**SERVICE BULLETIN**

**HOSE CLAMPS REPLACEMENT**

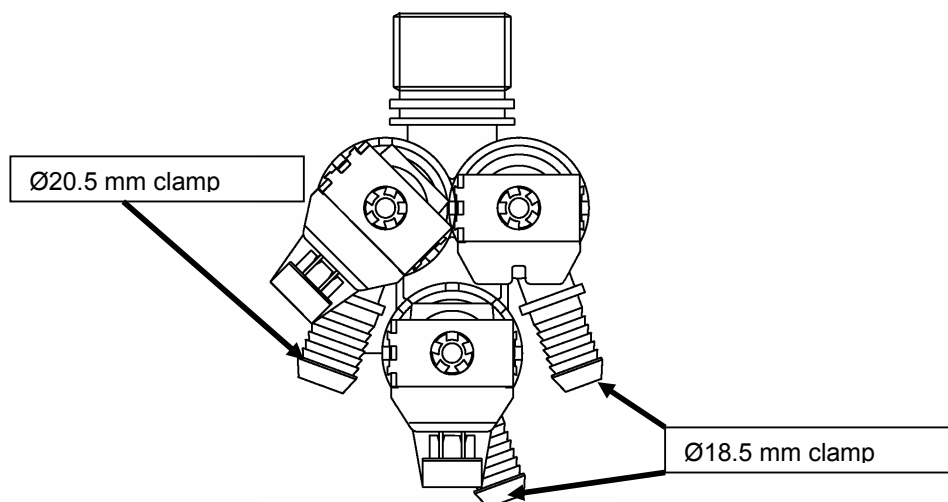
As from serial no. 529..., new hose clamps are fitted to the solenoid and to the conveyor (detergent drawer) on the PRIVILEG appliances.

When carrying out repair, it is necessary to cut the clamps by means of a cutting nipper and replace them with the kit part no. 5028 61 08-00/1, which includes the following six clamps (these ones can be opened and closed):

Part no.124 23 56-00/2 Ø 20,5mm (2 pcs.)

Part no.124 23 56-10/1 Ø 18,5mm (4 pcs.)

The quantity of clamps supplied with the kit are sufficient for one appliance with a three-way solenoid.

The above instruction applies also to the conveyor.
